Addendum #3

Re: Beaufort County Animal Shelter and Hilton Head Humane Association Animal Services Complex
Beaufort County, SC
10 Pritcher Point Road, Okatie, SC 29909
Bid Number: #041817E

This Addendum forms a part of the Contract Documents and modifies the original drawings and specifications dated 03/02/2017. Contractor shall be responsible to review changes to all portions of the work as changes of one portion may affect the work of another. Contractor shall indicate receipt of this addendum on the bid form.

EMBEDMENT DETAIL FOR REINFORCED CONCRETE PIPE

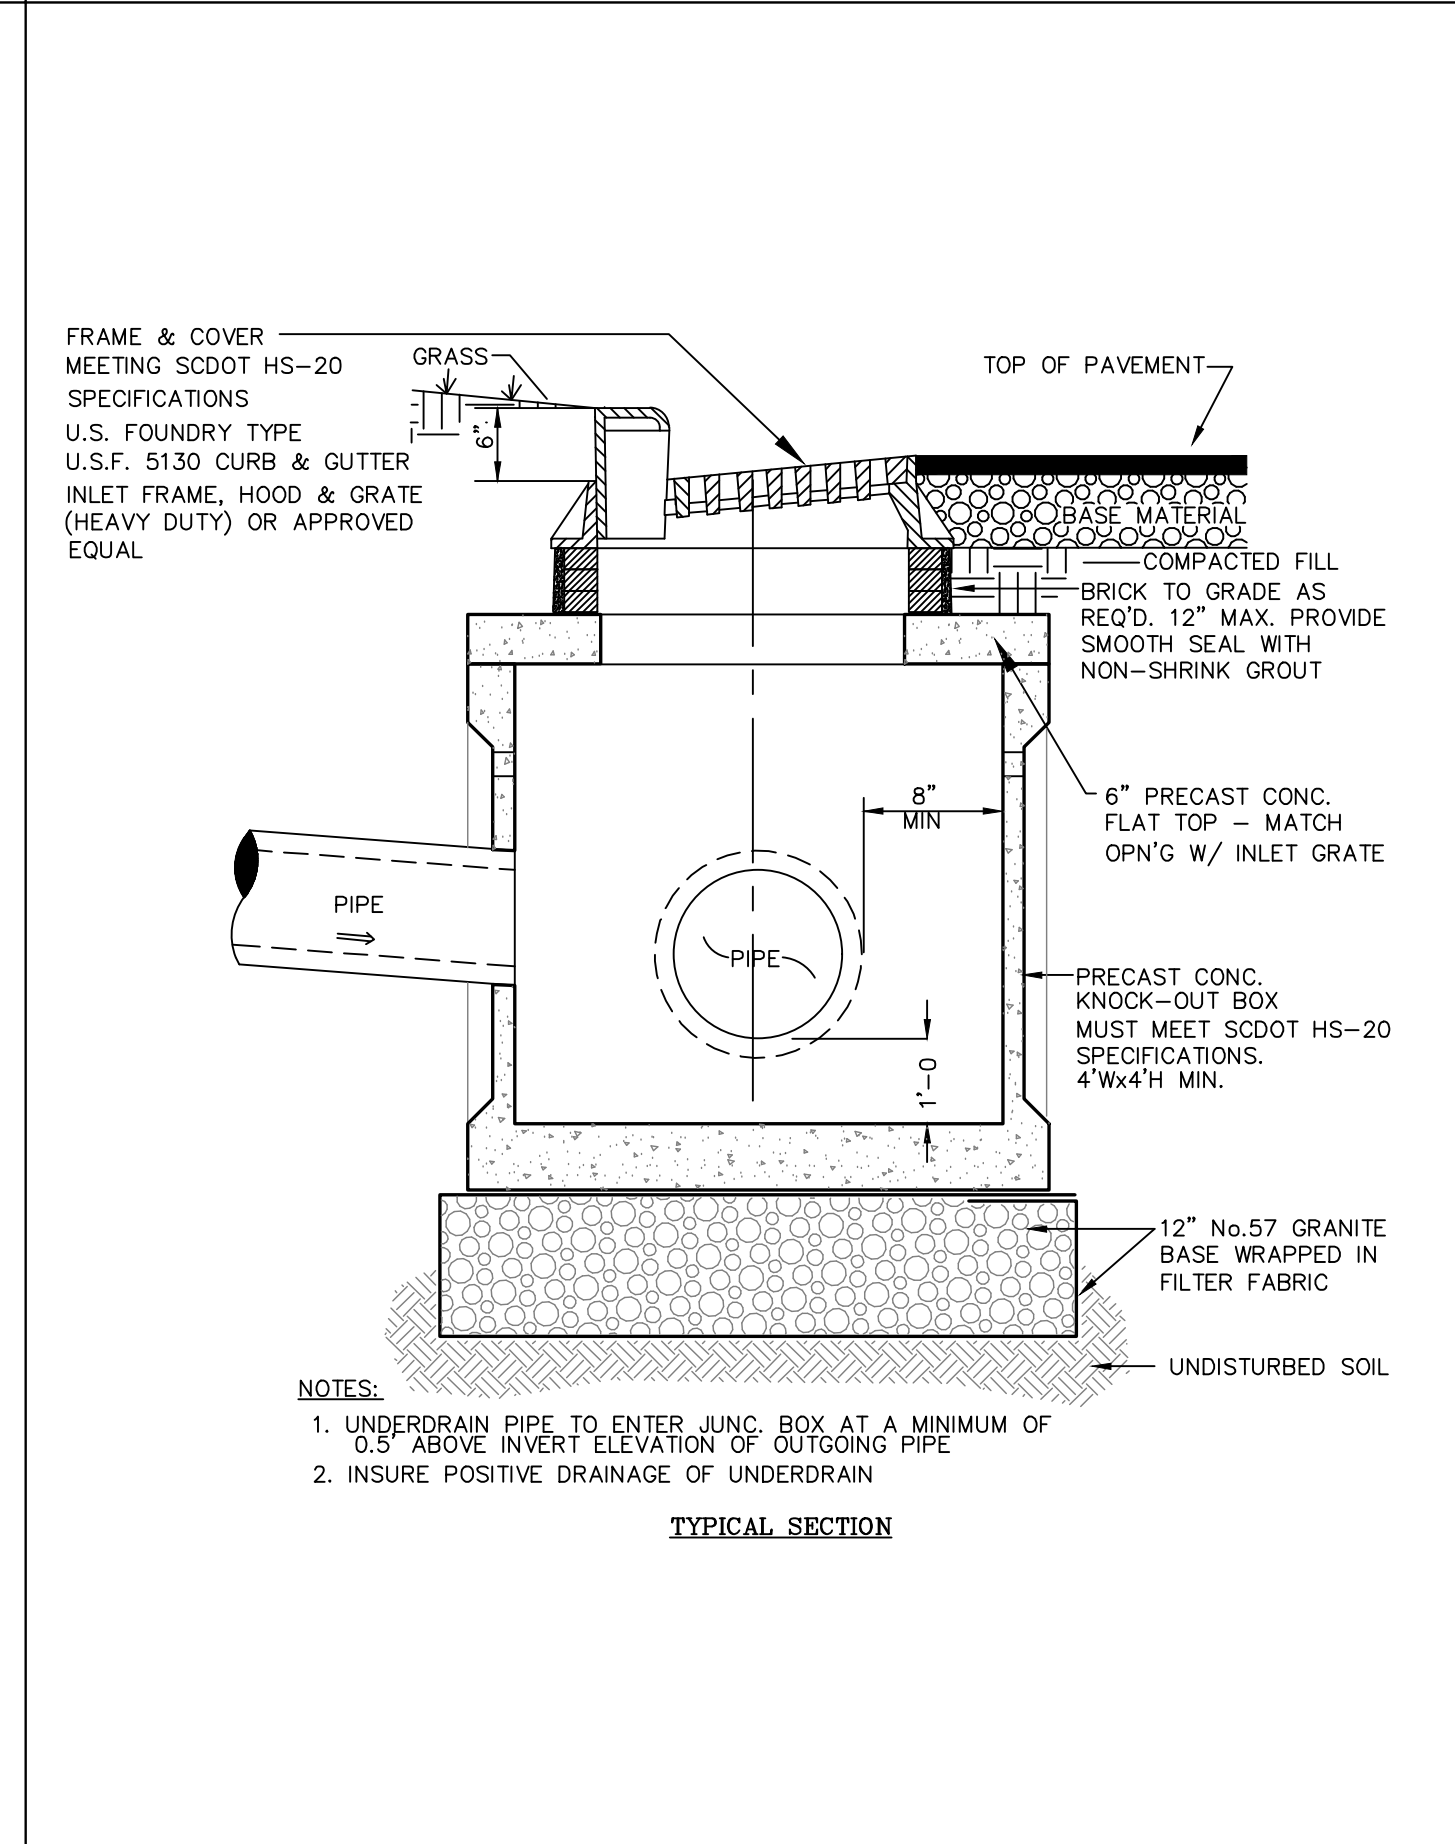
1. Revise the underdrain detail to add the location of the underdrains.
2. Refer to attached Sheet.

AGGREGATE PAVING SECTIONS
DETAIL 02740-016

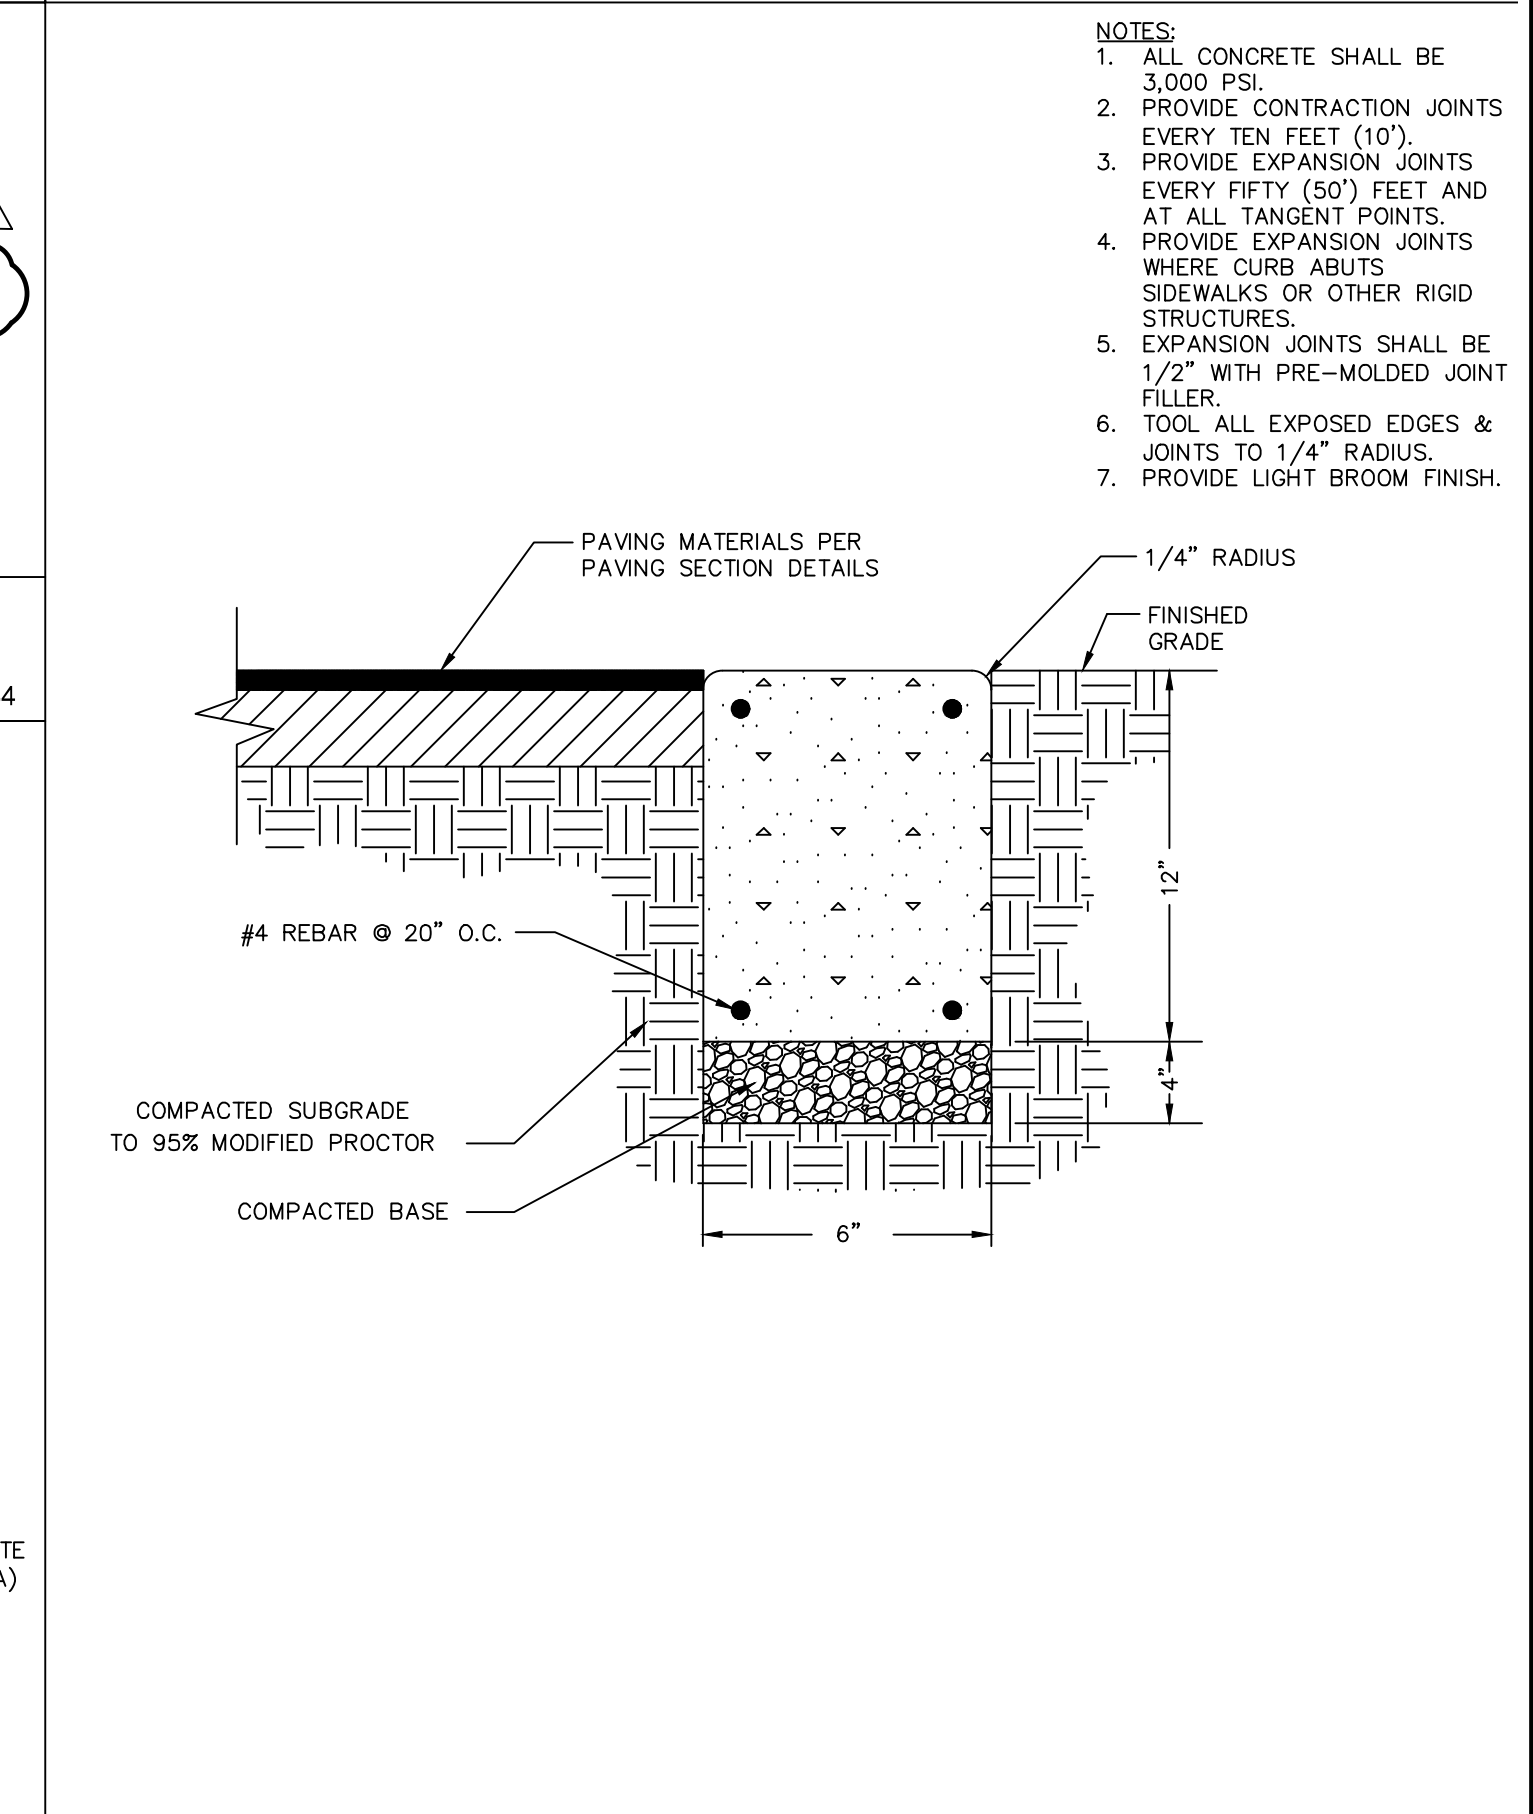
1. Revise the covered area (located near the Pump Station) to be Aggregate Paving in lieu of Gravel.
2. Refer to attached Sheet.

1. Revise details to show thickness of concrete paving base.
2. Refer to attached Sheet.
